Guelph/Eramosa Township Hydrogeology Agency Review Document Book

Hydrogeology Review Document Book Index

Re: Harden Response Letter Dated June 12, 2015
Project No.: 300032475.0000

**Re: JDCL Response to Hunter and Associates May 15, 2015 Peer Review
Project No.: 300032745.0000**

Fig 3.1

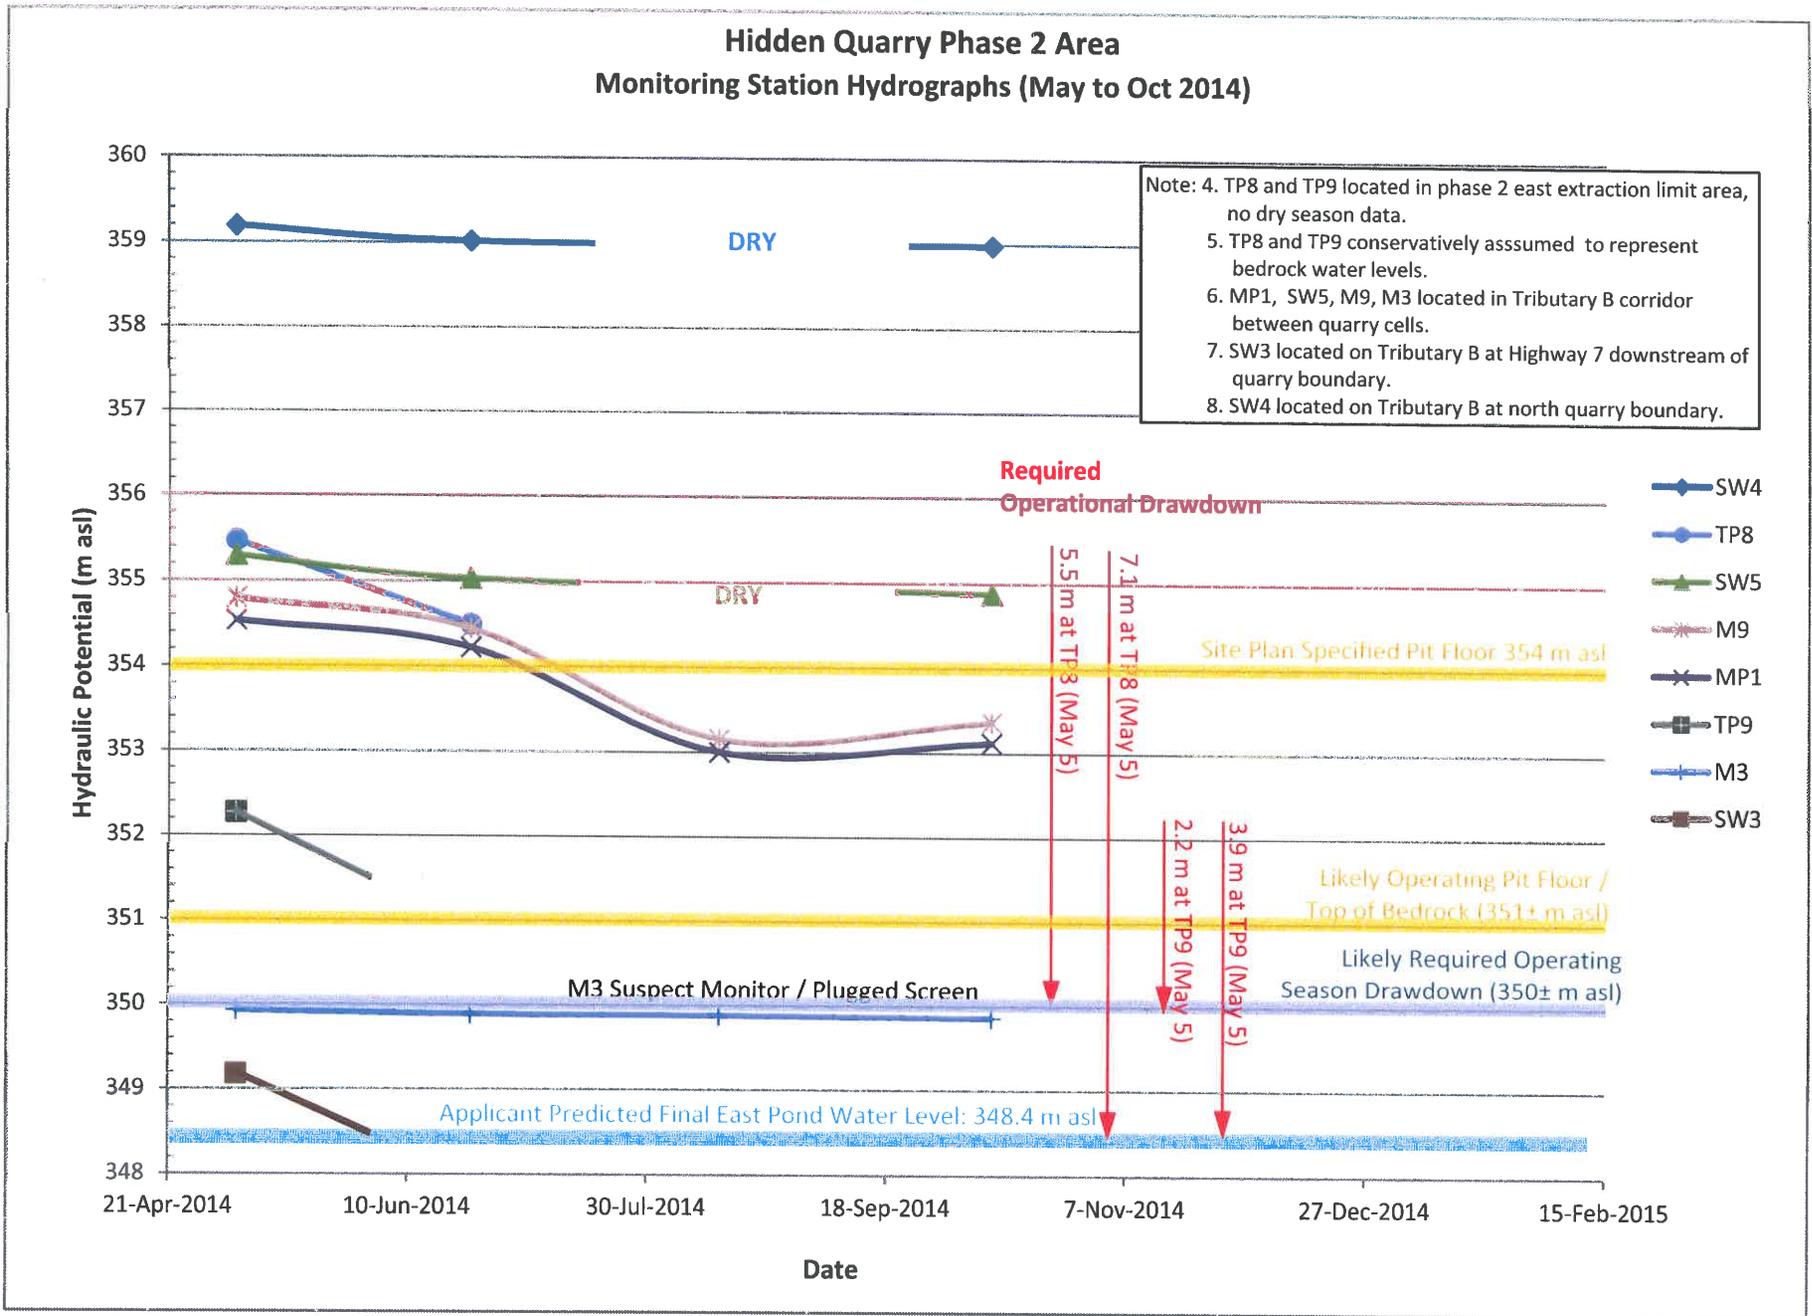
- Notwithstanding the Applicant Hydrogeologist's frequent statements that drawdowns will be gradually established, the Applicant's Operational Site Plan imposes maximum water table drawdowns in the north and west area of the quarry during overburden and weathered surface rock extraction prior to even initiating Phase 1 dolostone extraction (Fig 3.1).

Fig 3.1 The Applicant relied on its groundwater model to predict post-extraction final water levels. The Applicant did not have regard for the groundwater drawdowns required to actually operate the pit / quarry in accordance with its proposed Site Plans. This figure shows the actual operational drawdowns utilizing the Applicant's supplied May to October 2014 groundwater level monitoring as an analogue. Domestic well locations are shown on Fig 1.1 and the Applicant monitor locations on Fig 2.1. The actual drawdowns for the most part, especially during the spring season, significantly exceed the Applicant's post-extraction model estimates.

Fig 3.2

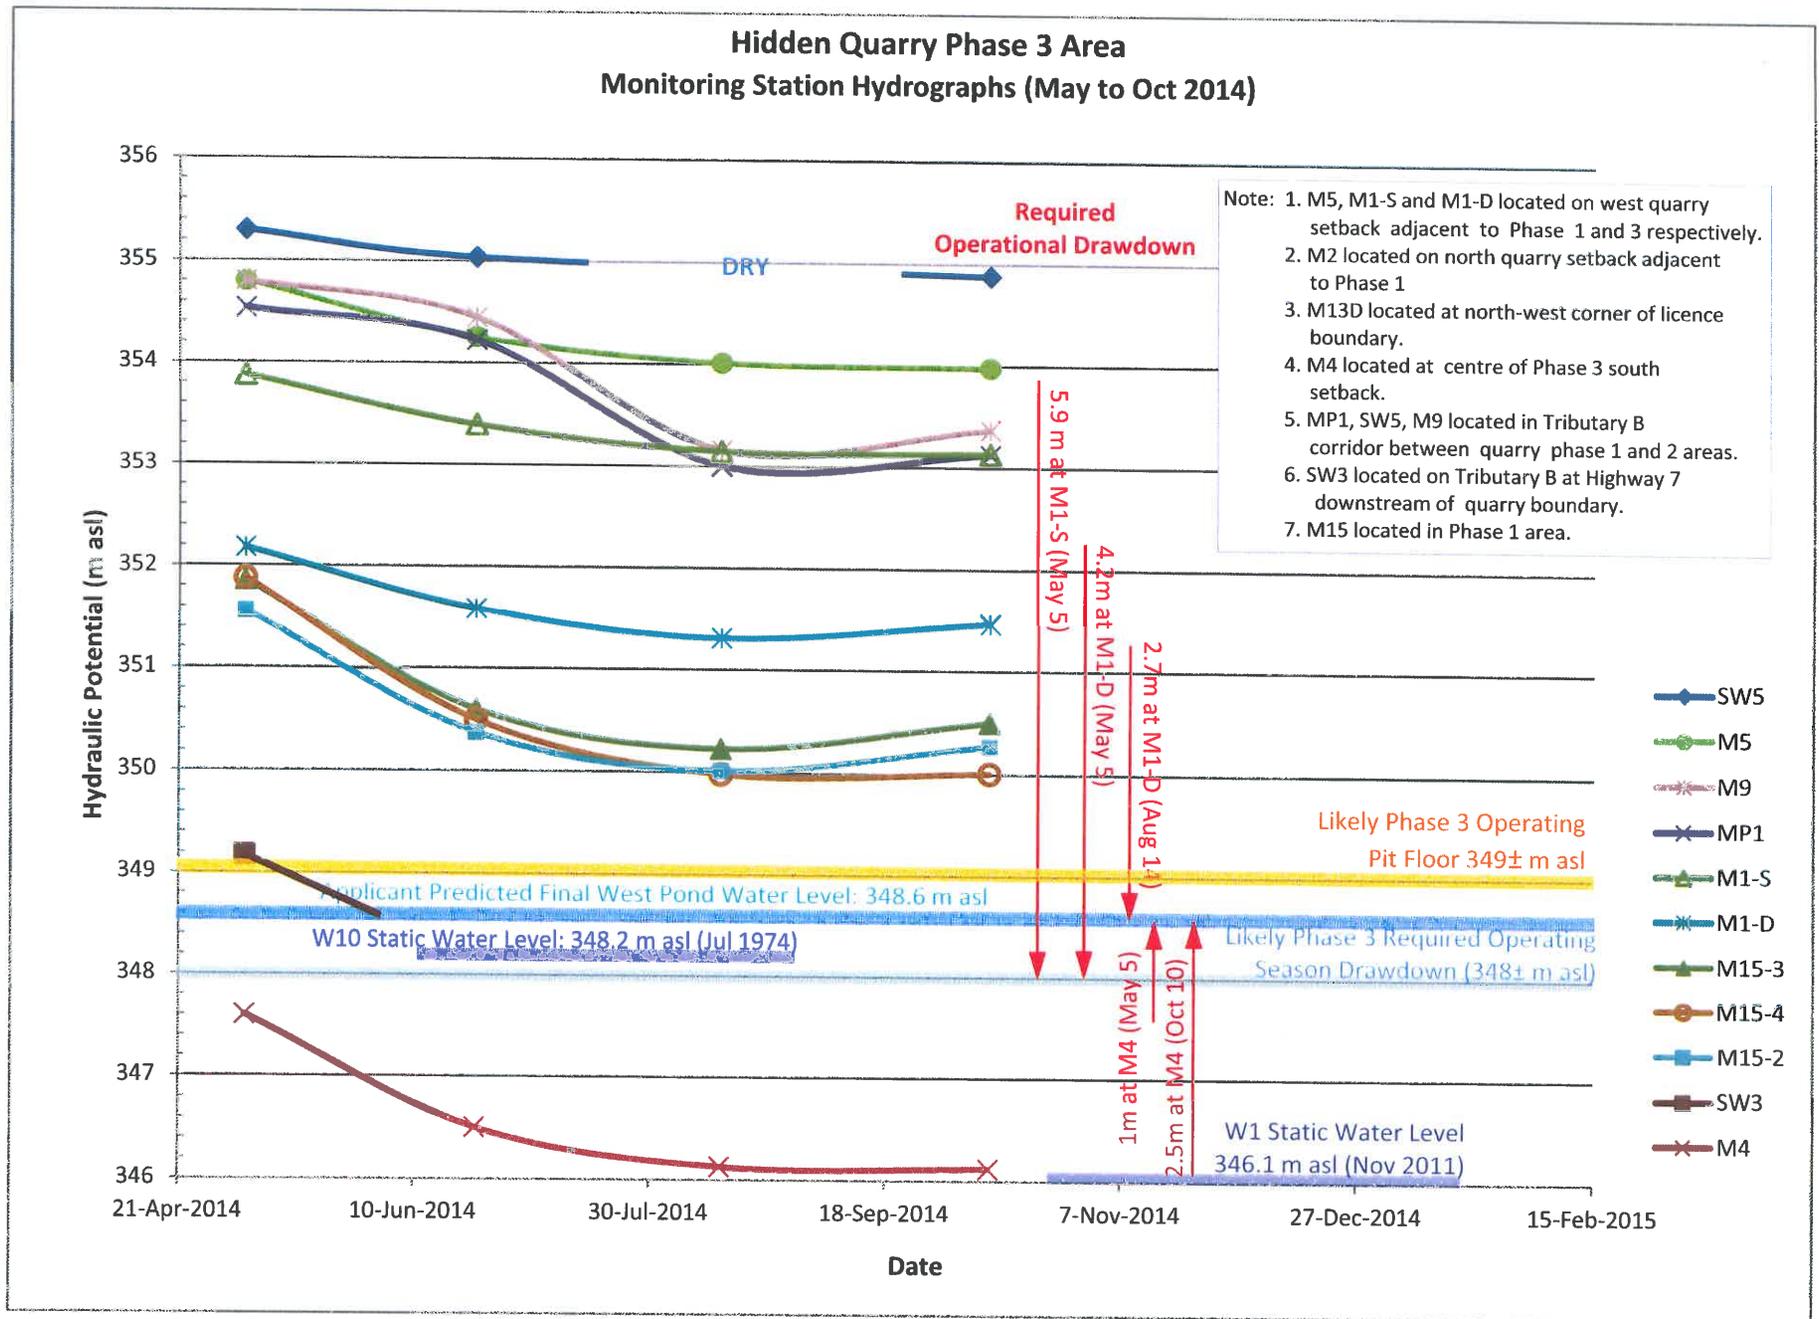
The proposed Operating Pit Floor (bottom of sand and gravel / top of dolostone) is a consistent 354 m asl in the Noise, Blasting Reports and on the March 19, 2015 proposed Site Plan version. **This Peer Review has assumed a Phase 2 pit floor at 351 m asl pit / quarry dry operational floor with a water table at 350 m asl (Fig 3.2) (see Sec 3.1 this report).**

- The Applicant has a deficiency of base of overburden / top of bedrock observations, no bedrock groundwater level monitoring and limited overburden water level monitoring in Phase 2 area. There is no technical support for the top of bedrock dry operating pit and quarry floor at 354 m asl as specified on the Site Plan (Fig 1.7).
- For my analysis I have assumed the Pit floor in the Phase 2 area at a more realistic 351 m asl. A lower operating dry staging platform offers greater acoustic protection for neighbours (Fig 3.2).

Fig 3.3

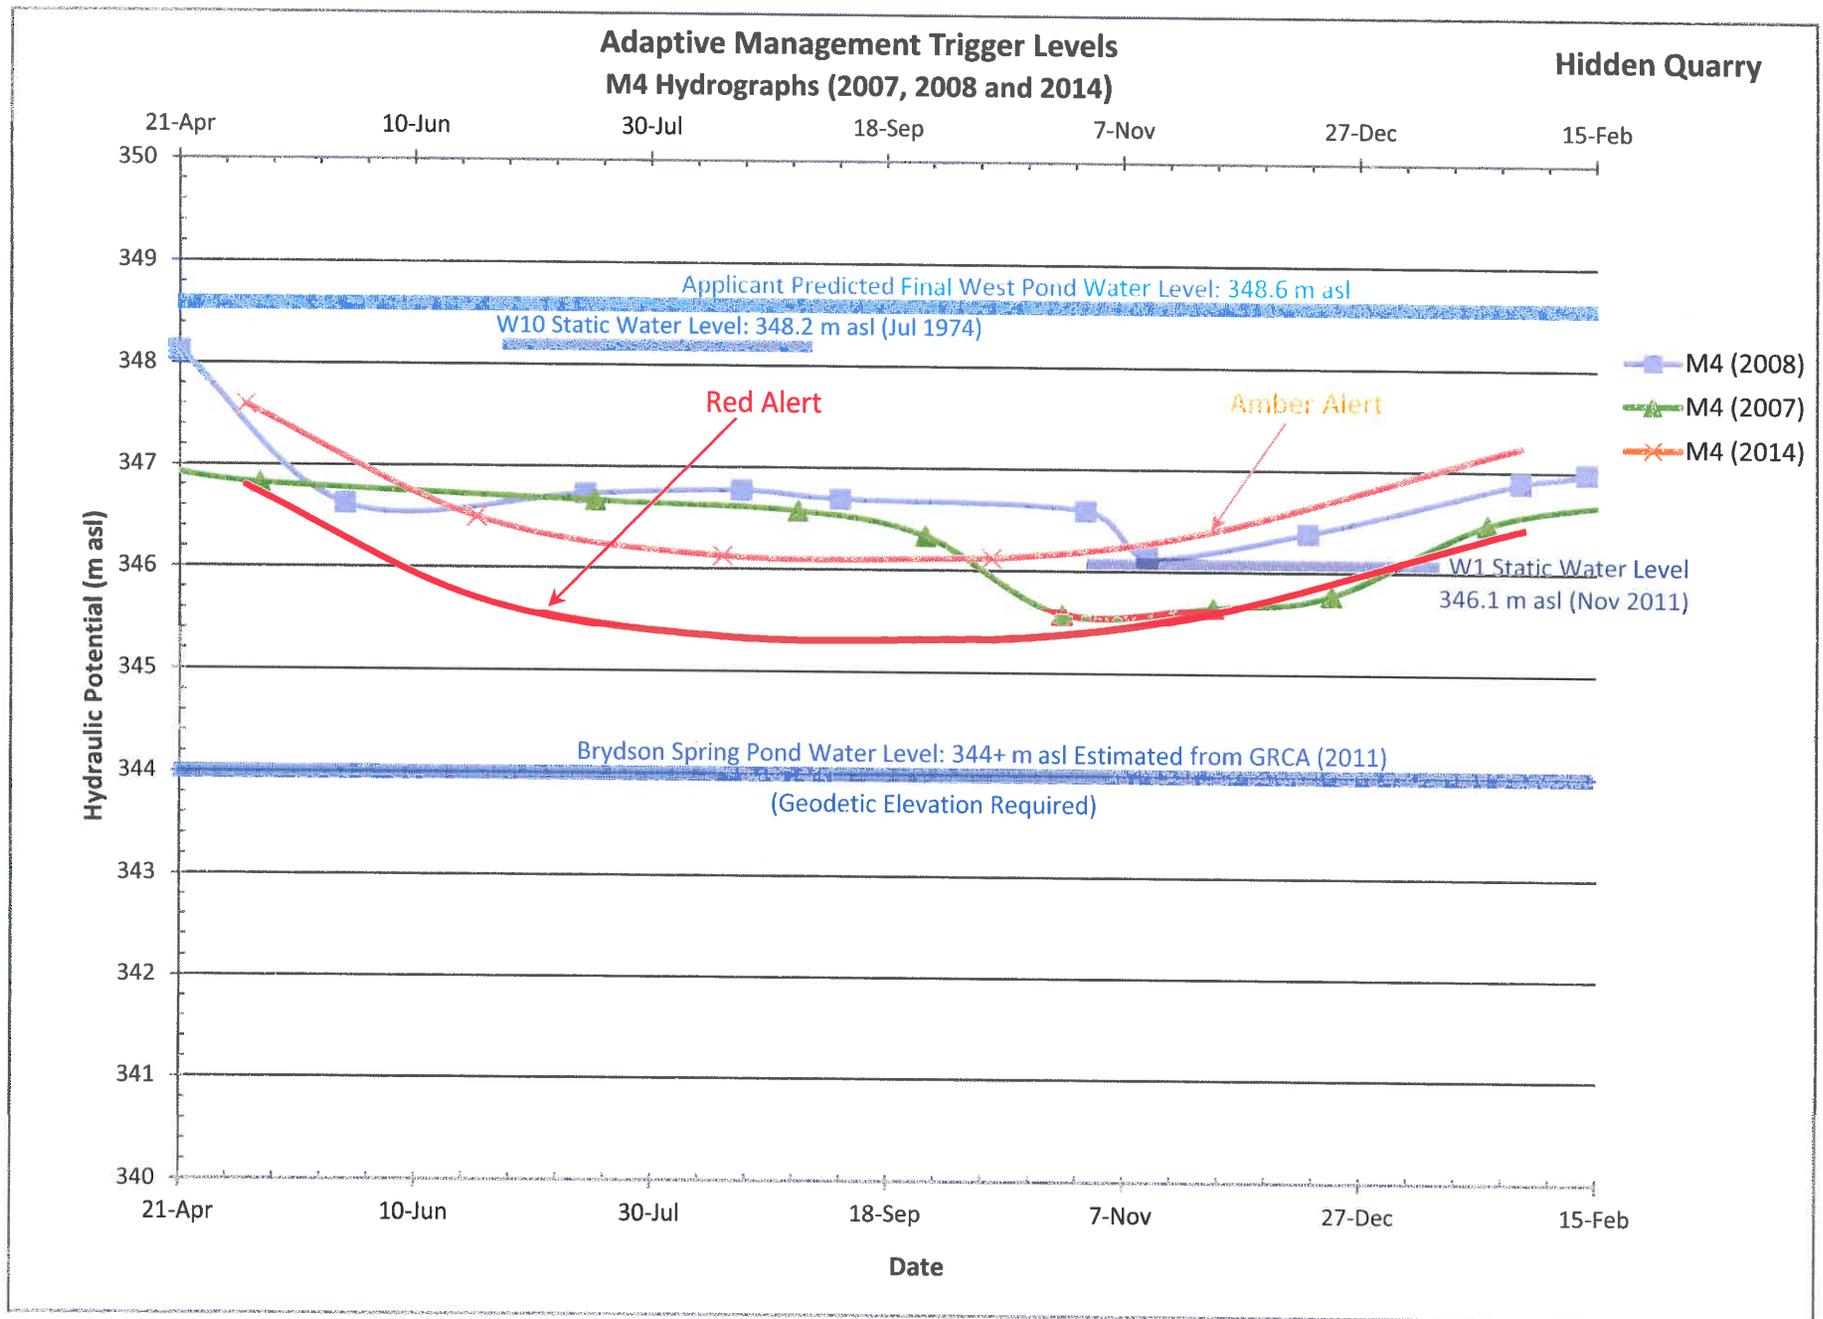
The Site Plan required operational drawdown in Phase 3 is to about 348 ± m asl slightly lower than the model predicted post extraction water level 348.6 m asl (Fig 3.3). **M4 static levels are less than 1 m below the required drawdown in the 2014 spring season and nearly 2 m below in the 2014 summer and fall seasons.**
